Winegard Connect 1.0 to WIFI Ranger

Bulletin Type:	SRP	Publication Date:	December 2023
Bulletin #(s):	23-124	Make(s):	Entegra Coach
Job Code(s):	<i>If affected unit has warranty remaining, submit your claim following the normal process</i>	Model(s):	Cornerstone, Anthem
Flat Rate(s):		Model Year(s):	2022

Incident:	Connect 1.0 component failure
Affected Units:	2022 Entegra Coach Cornerstone & Anthem
Parts List:	1 - ANTENNA,WIFI RANGER SYS BLK MFR# WR-0108 (Jayco Part #2034200) 1 - ADAPTER,PWR SPLY 120VAC TO 12V DC FOR WIFI RANGER (Jayco Part #2056827) 12ft-16ft - 2 12v wire (Purchase Locally) 3ft - Butyl putty tape (Purchase Locally) 2 - SILICONE,NUFLEX #311 BLK SELF LVLG TUBE (Jayco Part #0260646) 15 - SCREW,PAN QUAD 8.00X1.00 TWST BLK (Jayco Part #0011707) 2 - Female slide terminal (Purchase Locally) 2 - Butt connector/wago (Purchase Locally)
Misc. Tools & Supplies:	✓ Screw gun ✓ Square head bit ✓ 9mm nut driver/socket ✓ Putty scraper ✓ 1.5" hole saw bit ✓ Spray foam ✓ Pull wire/wire snake ✓ Alcohol ✓ Wipes/paper towel

Fig. 8

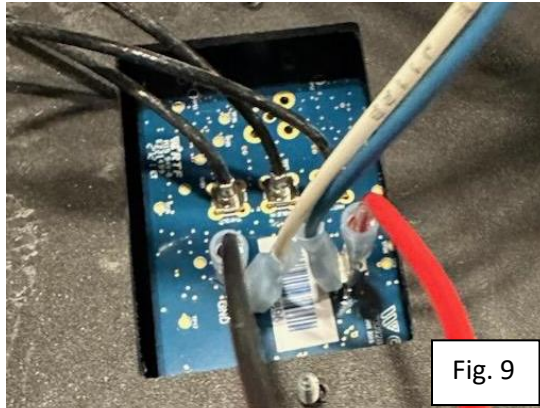
13. Mount Denali facing forward and straight using the 1" screws.
14. Apply butyl tape to roof cap and re-apply to roof.
15. Using the self-level sealant, seal around the base of the Denali and roof cap, covering the screws and base plates. (Figure 8).
16. Connect 16-2 12v wire in parallel to existing wiring on the antenna power switch. (Figure 9)
